Date: September 7, 2023  
To: TRPA Hearings Officer  
From: TRPA Staff  
Subject: Single-Family Residential Rebuild for North Shore TVCA LLC,  
6650 North Lake Boulevard, Tahoe Vista, Placer County, CA; Assessor's Parcel  
Number (APN): 117-072-006; TRPA File No.: ERSP2023-0707

**Requested Action:**

**9**  
C2.1  
BIO-SWALE TYPICAL SECTION WITH SUBSURFACE TREATMENT  
NTS

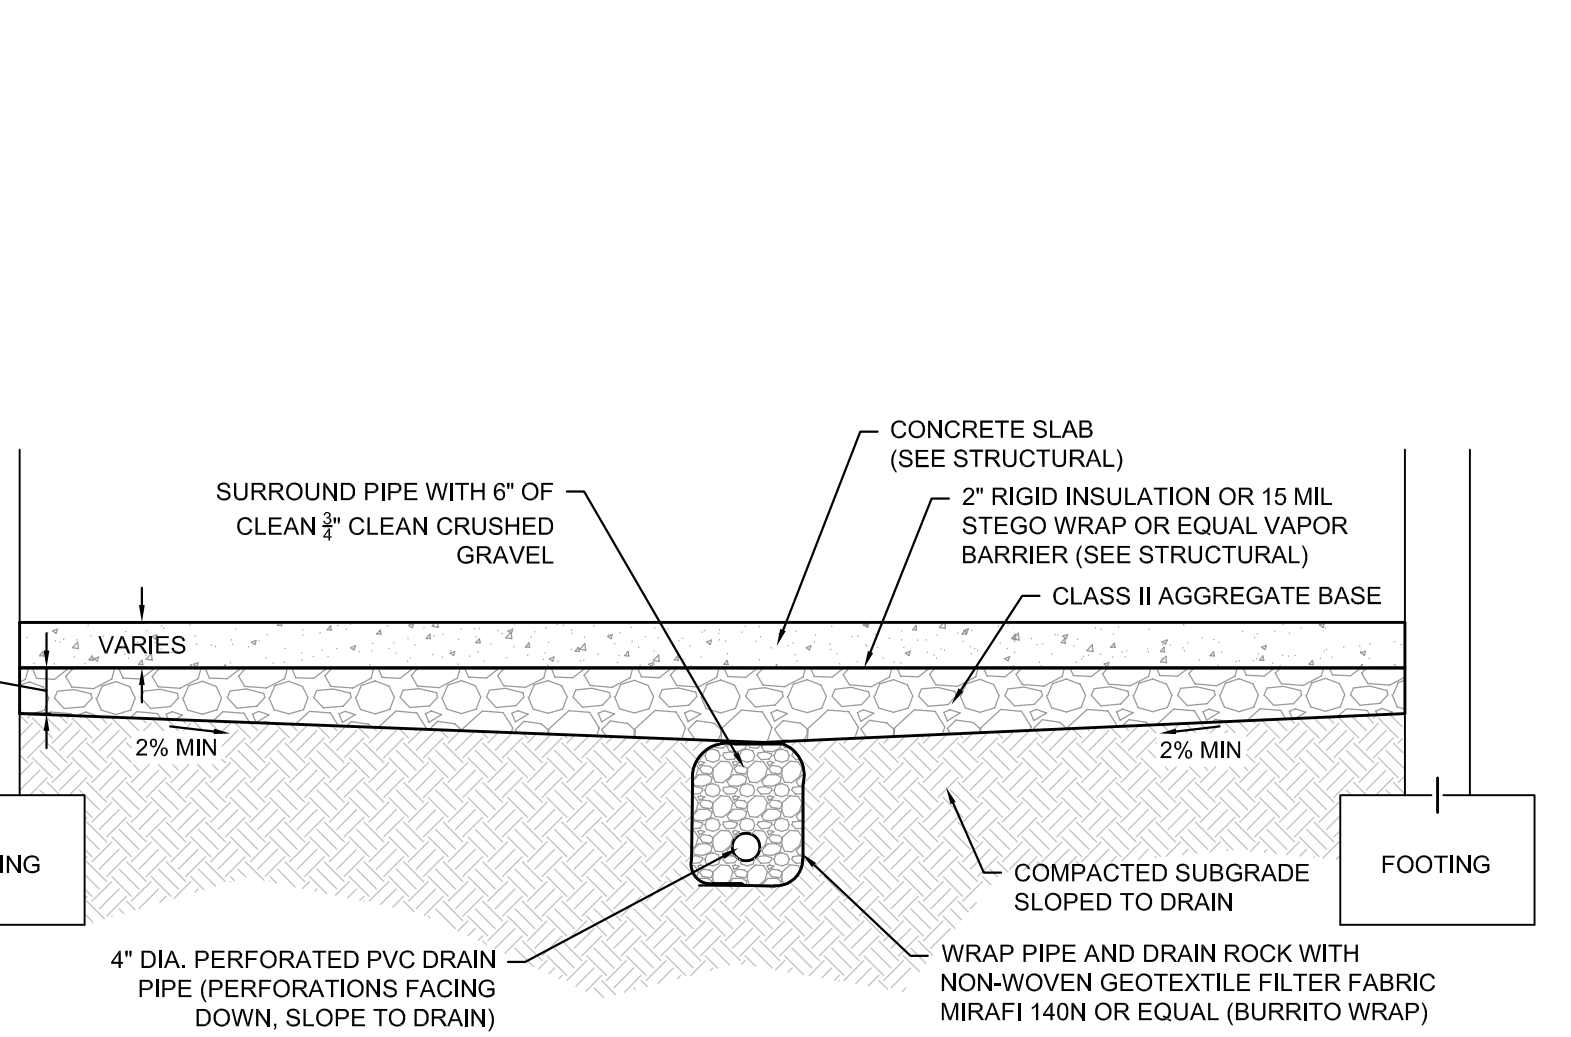
- (8) Remove the perforated pipe from BMP treatments C and D. Reference detail 9/C2.1 for treatment D.
- (9) Modify BMP treatments E and K to use shallow infiltration facilities that do not extend below elevation 6,230.1' (the high water elevation of Lake Tahoe plus 1 foot). Also modify treatment M to not extend below elevation 6,230.1'.
